SERVICE CAMPAIGN BULLETIN

NTB12-002

VOLUNTARY SERVICE CAMPAIGN 2011 – 2012 MURANO CROSS CABRIOLET SOFT TOP OUTER FLAP ADJUSTMENT BOLT

CAMPAIGN I.D. #: P1258**APPLIED VEHICLES:** 2011 – 2012 Murano Cross Cabriolet (EZ51)**Check Service Comm to confirm campaign eligibility.**

Figure 2

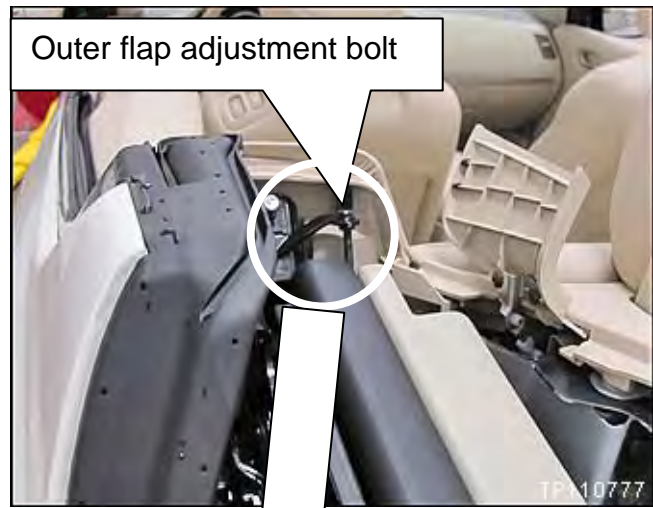
2. Locate the outer flap adjustment bolt (see Figures 2 and 3).

Figure 3

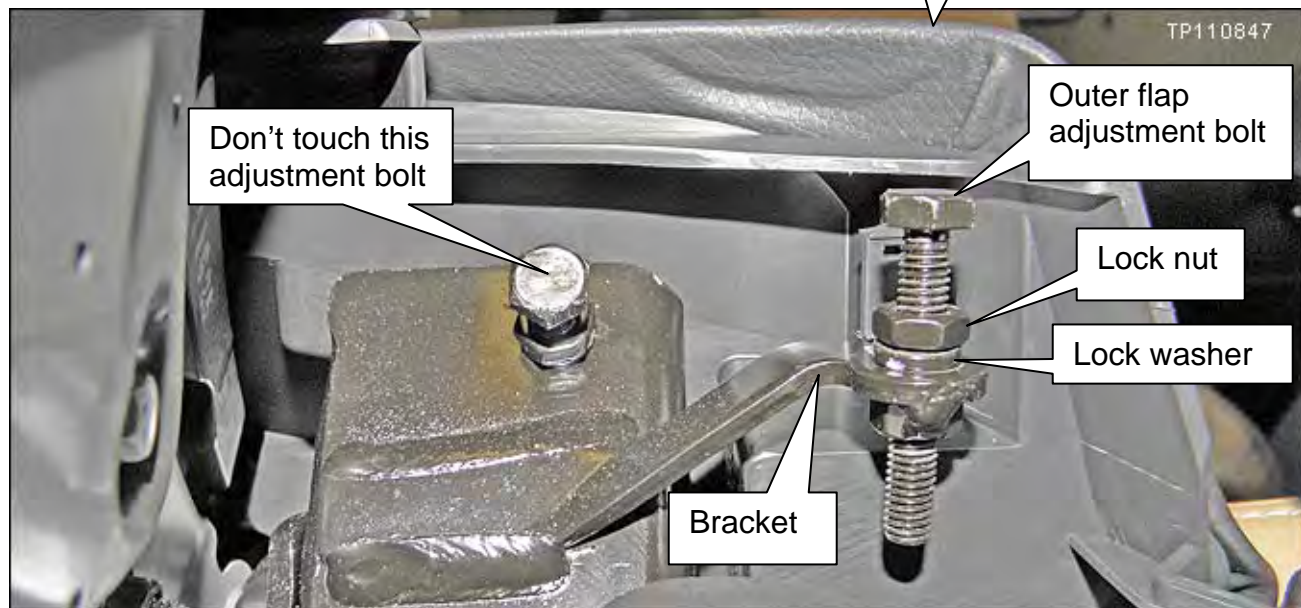
3. Remove the outer flap adjustment bolt from the bracket (see Figure 3).

4. Remove the lock nut from the outer flap adjustment bolt.

Figure 4

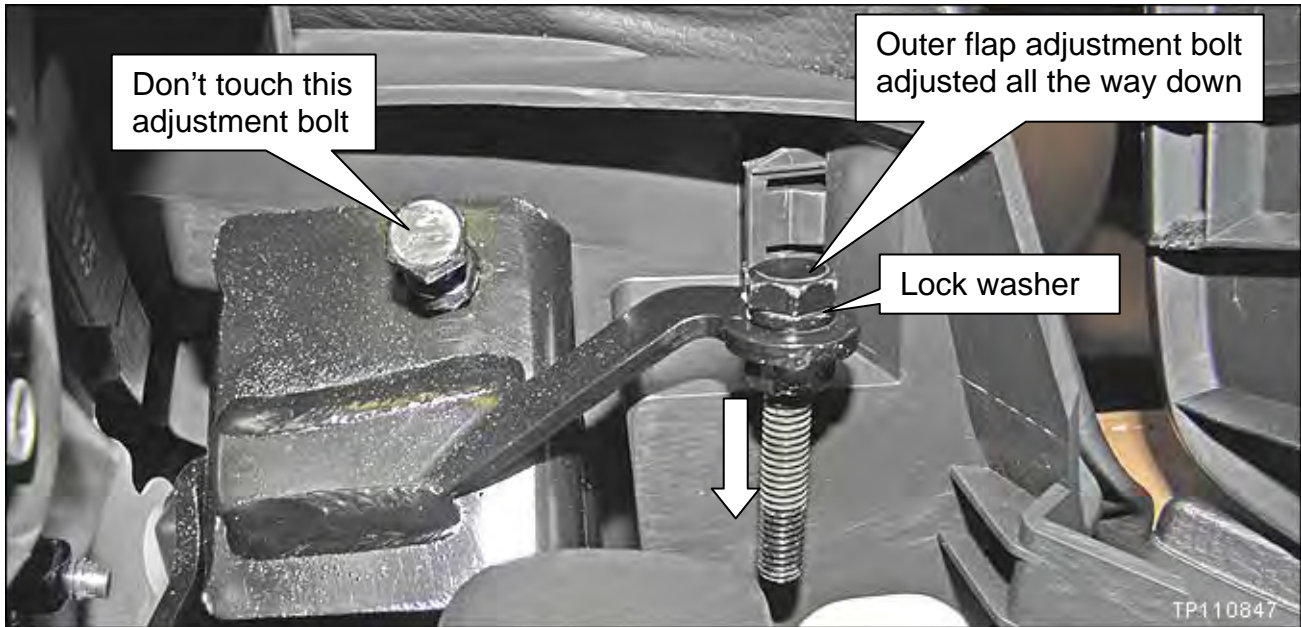
5. Reinstall the outer flap adjustment bolt **with lock washer** (see Figure 4).
6. Screw the outer flap adjustment bolt all the way down as shown in Figure 4 and torque to 5.4 N•m (0.55 kg-m, **4 ft-lb**).
7. Make sure to perform this procedure for both the left and right side.
